Shearwater Perdix 2 Firmware Release Notes

VERSION 99 2024-12-18

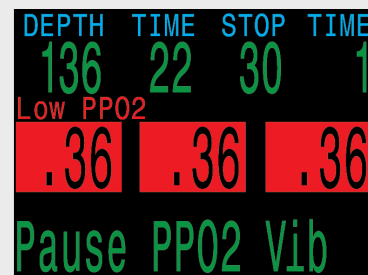
Continuous vibrating alarms for externally monitored (CCR) low and high PPO2 have been added.

Due to the critical importance of PPO2 levels in a closed-circuit rebreather, externally monitored PPO2 alarms will continue to vibrate every 10 seconds, even after the message has been acknowledged, as long as the alarm condition remains.

When a Low or High external PPO2 alarm exists, the vibrating alarm will continue even after the Warning message has been cleared.

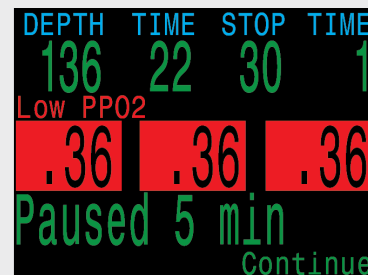
A “Pause PPO2 Vib.” Menu option will be available while a PPO2 vibrating alarm condition is active. This will pause PPO2 vibrating alarms for five (5) minutes. During this time other warning conditions will still cause vibrations.

While such vibrations are active, a menu option will be available to Pause PPO2 Vibrations

This will pause vibrations for 5 minutes

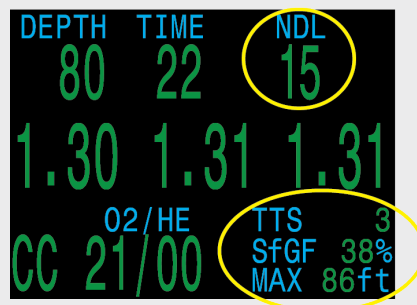
The “NDL Display” setting can be set to “Mini”. The Mini display can be configured to show 2 custom values, in addition to TTS which is fixed. The main display is slightly changed, with NDL moving up to the top right where DECO STOP is normally shown. NDL will show here until deco stops are needed, at which time it will change automatically to show deco stops.

A MINI display be chosen as the NDL Display setting

This option will move NDL up to the DECO STOP area. Once deco stops are needed they will replace the NDL.

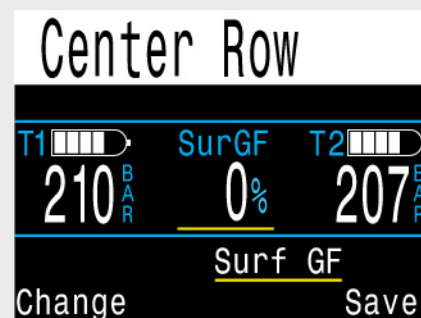
Previews of the tec center row display configuration have been added to make display setup easier.

Also, more options are available in the tec modes center position.

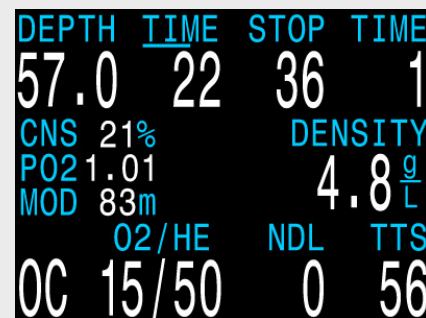
Gas density display is now available.

It is only available in the configurable main screen display. It shows gas density in g/L.

The gas density display turns yellow at 5.2 g/L and red at 6.3 g/L. No other warnings are generated.

The gas density display turns yellow at 6.3 g/L. No other warnings are generated.

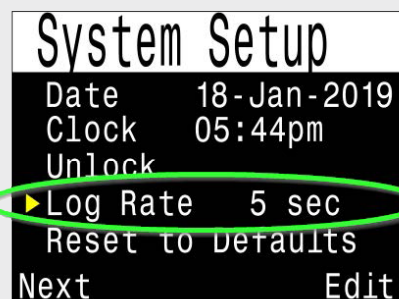
Log sampling rate can be set to 2, 5, or 10 seconds (previously always 10 seconds). Note that log downloads may take longer with faster sampling rates as more data is being recorded. Also, less logs can be stored until they are overwritten. For example, about 1000 hours are stored at a 10 second rate, but only 200 hours at a 2 second rate.

Log Rate can be set to 2, 5, or 10 seconds

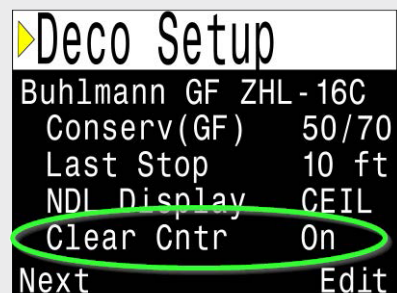
A “Deco Clear” up-counter option has been added.

When deco clears this counter begins counting up from 0. It is useful for timing additional padding after the mandatory decompression stops. If the dive did not need deco, then begins upon entering the safety stop zone (i.e. shallower than 20ft / 6m).

The “Clear Counter” counts up once deco is clear

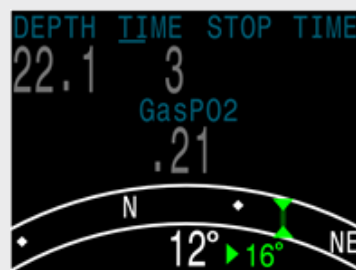
Compass mark heading menu moved to reduce button presses. Also, the compass can now be viewed while marking. Operation: when viewing compass a left button press brings up an "Exit/Mark" menu. Right press marks compass, Left press exits to main screen. Previously had to navigate to regular menus to mark the compass.

The mark heading command now requires less button presses
